ARCHITECTURAL REVIEW BOARD STAFF REPORT

Project #/Name	ARB-2025-22: Fasmart Store – Major Amendment
Review Type	Major Amendment
Parcel Identification	056A1010012400
Location	1248 Crozet Avenue (Figure 1)
Zoned	Downtown Crozet District (DCD) / Entrance Corridor (EC)
Owner/Applicant	Sappington Revocable Living Trust / Pulley (Katie Gray)
Magisterial District	White Hall
Proposal	To revise the exterior of the building by painting it black and adding Nichiha panels on a portion of the side elevation.
Context	This site is located in Downtown Crozet, with commercial properties to the east, residences and converted residences to the north, the Crozet Depot to the southeast, and additional commercial properties to the south across the railroad tracks.
Visibility	This development is readily visible from the Entrance Corridor.
ARB Meeting Date	October 6, 2025
Staff Contact	Margaret Maliszewski

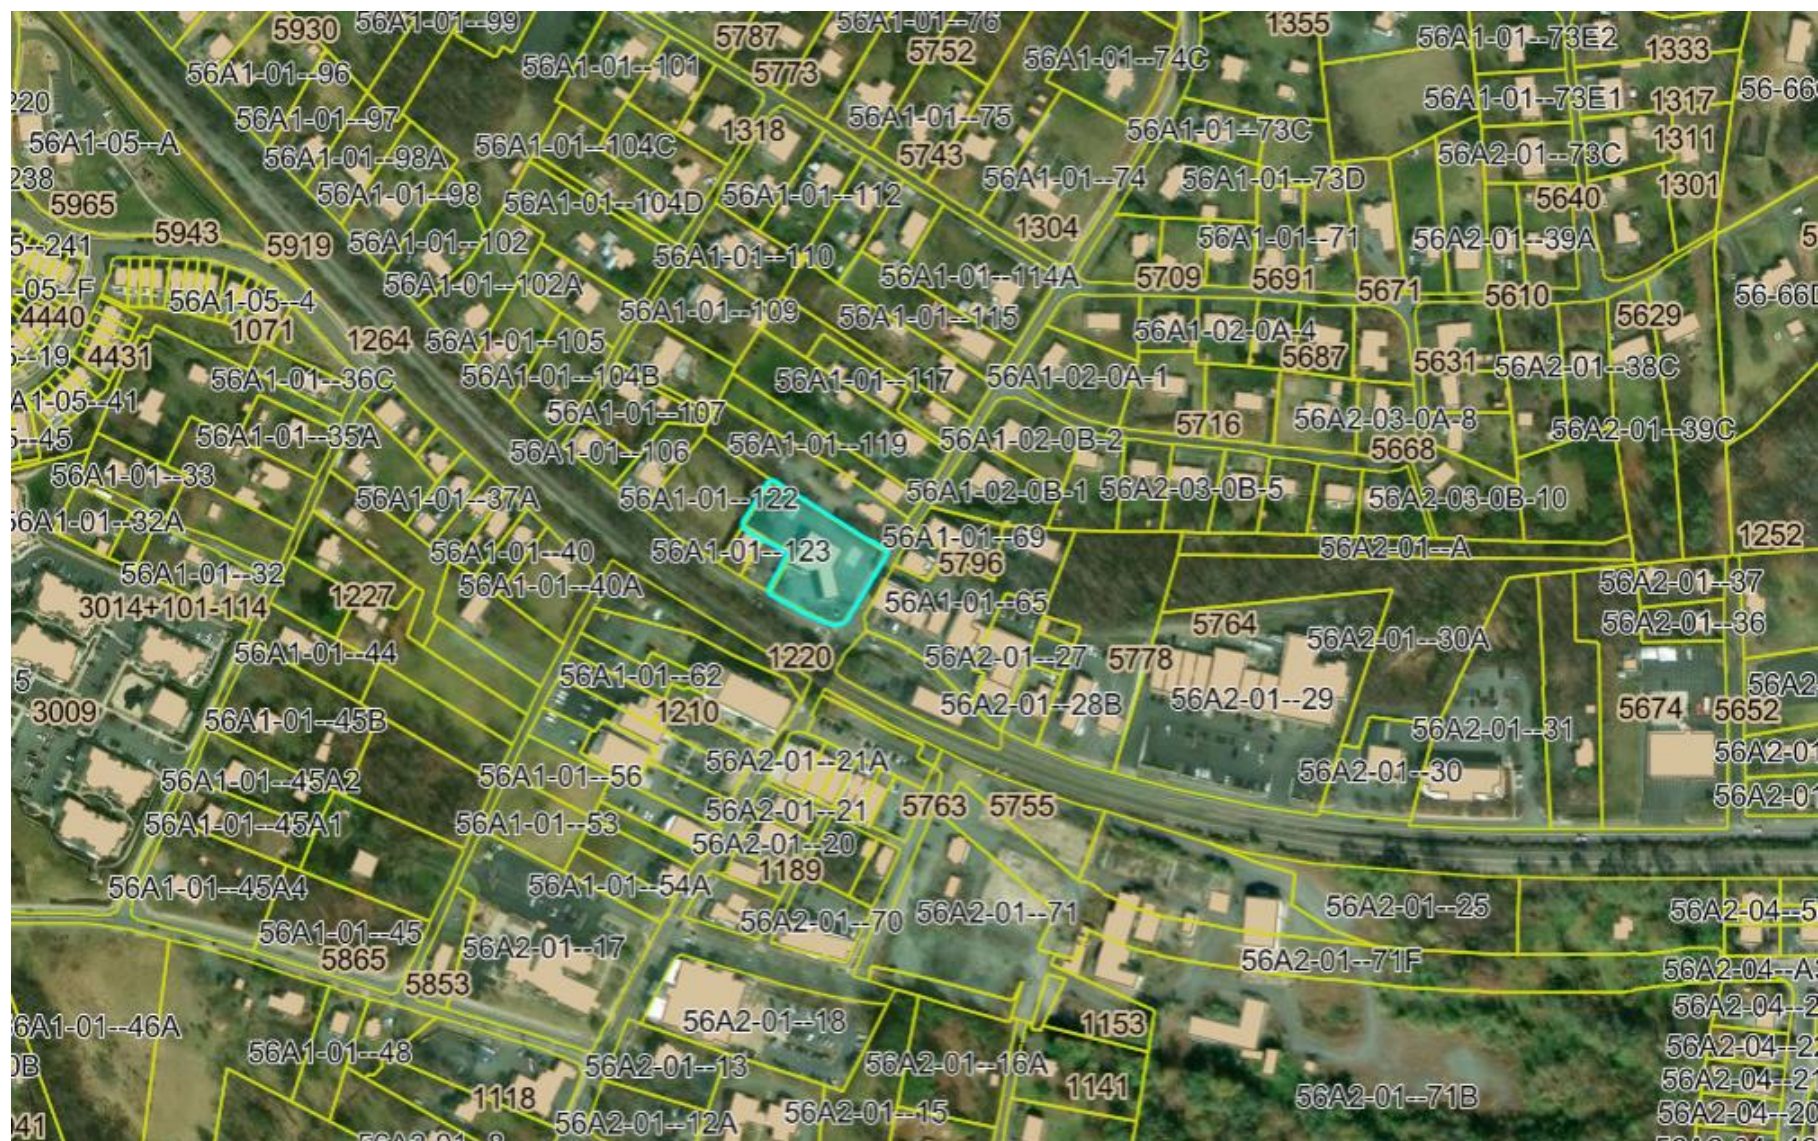
<i>Existing wall sign with decorative brick surround.</i>	
5	It is also an important objective of the Guidelines to establish a pattern of compatible architectural characteristics throughout the Entrance Corridor in order to achieve unity and coherence. Building designs should demonstrate sensitivity to other nearby structures within the Entrance Corridor. Where a designated corridor is substantially developed, these Guidelines require striking a careful balance between harmonizing new development with the existing character of the corridor and achieving compatibility with the significant historic sites in the area.	Painting the red brick black will make the building incompatible with nearby buildings whose predominant colors are shades of red and brown and off-white tones. The black painted brick is expected to appear unbalanced with nearby development and it is not expected to contribute to a cohesive appearance on the corridor.
